Delayed Deck Engagement

Product: Groundsmaster 4500 & 4700-D

May 7, 2008

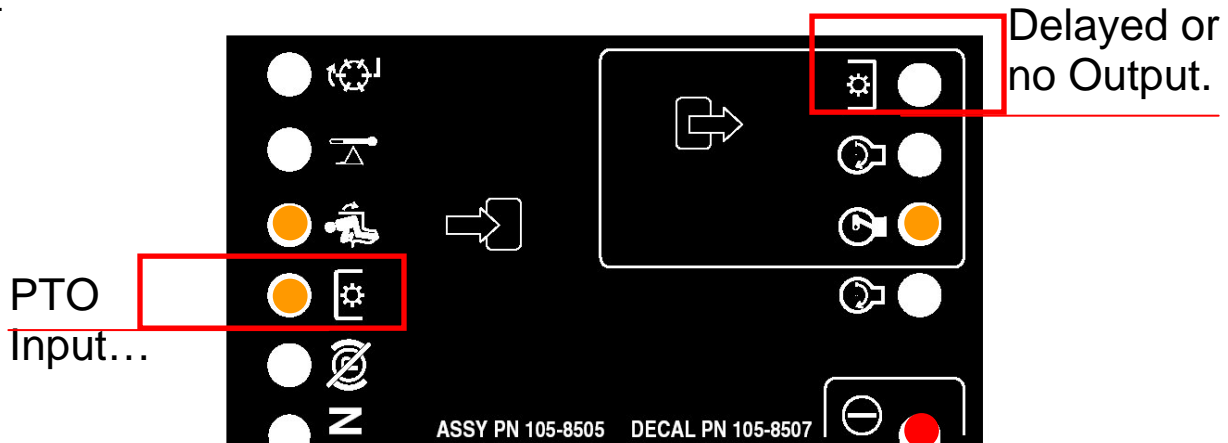
Remove the Operator's Console Cover on the right side of the machine. While sitting in the seat, turn the key to the On position, but do not start engine. Turn on the PTO Switch and observe the LED Lights on the Standard Control Module (SCM). The PTO Input light will illuminate (on the SCM) but the PTO Output light does not light (or the Ramp-Up Module) for up to 30 seconds or more. Review the machine Operators Manual and the picture below for additional details.

A replacement SCM (106-9277) and a PTO Converter Harness (110-8839) are required. The SCM is faulty and the Converter Harness will help keep the problem from reoccurring.

Installation Instructions for PTO Converter Harness (110-8839)

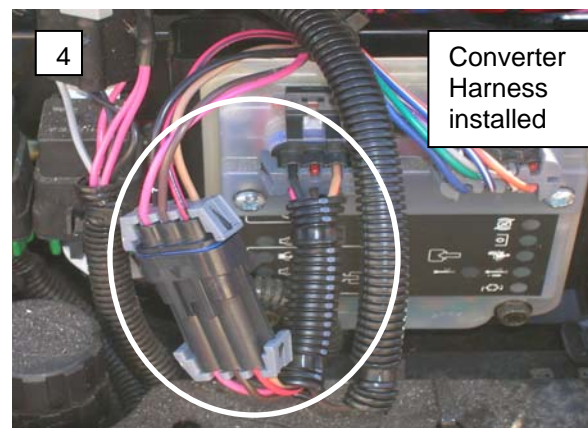
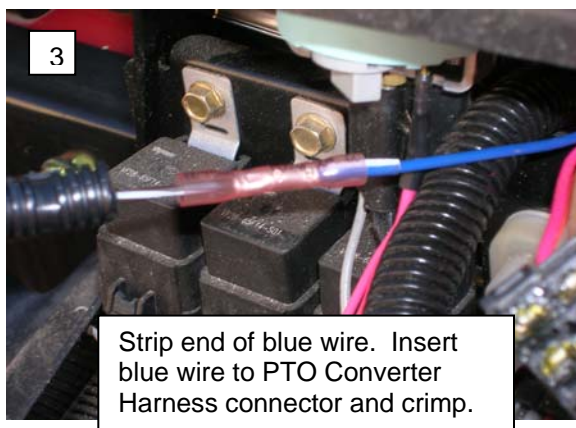
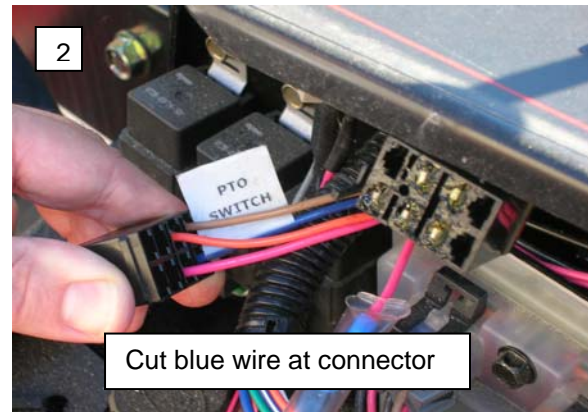
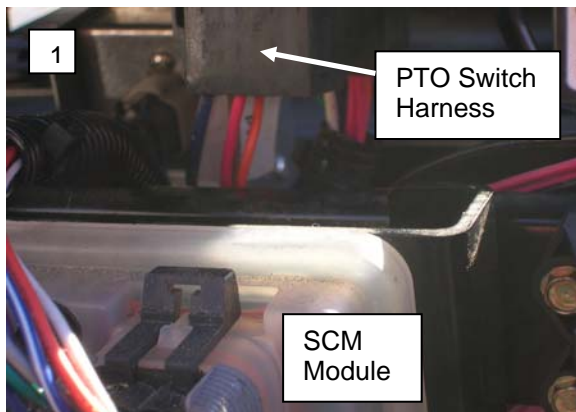
3. Locate the PTO Switch. Disconnect the wire harness connector at the underside of the switch (pic.1). Pull connector outwards to access wires.
Note: 4 wires on PTO Switch connector. They are blue, pink, orange & brown.

4. Cut the blue wire at the PTO Switch connector. Once cut, re-install the Switch connector onto the PTO Switch (pic.2).
5. Hold loose blue wire and strip back approx. ¼" of wire insulation. Insert the stripped blue wire end into the crimp connector of the Converter Harness. Use suitable pliers to crimp (pic 3).

6. Unplug the male 5 wire connector from the SCM Module. Plug into the female Converter Harness connector.
7. Plug the male connector of the Converter Harness into the SCM (pic 4).
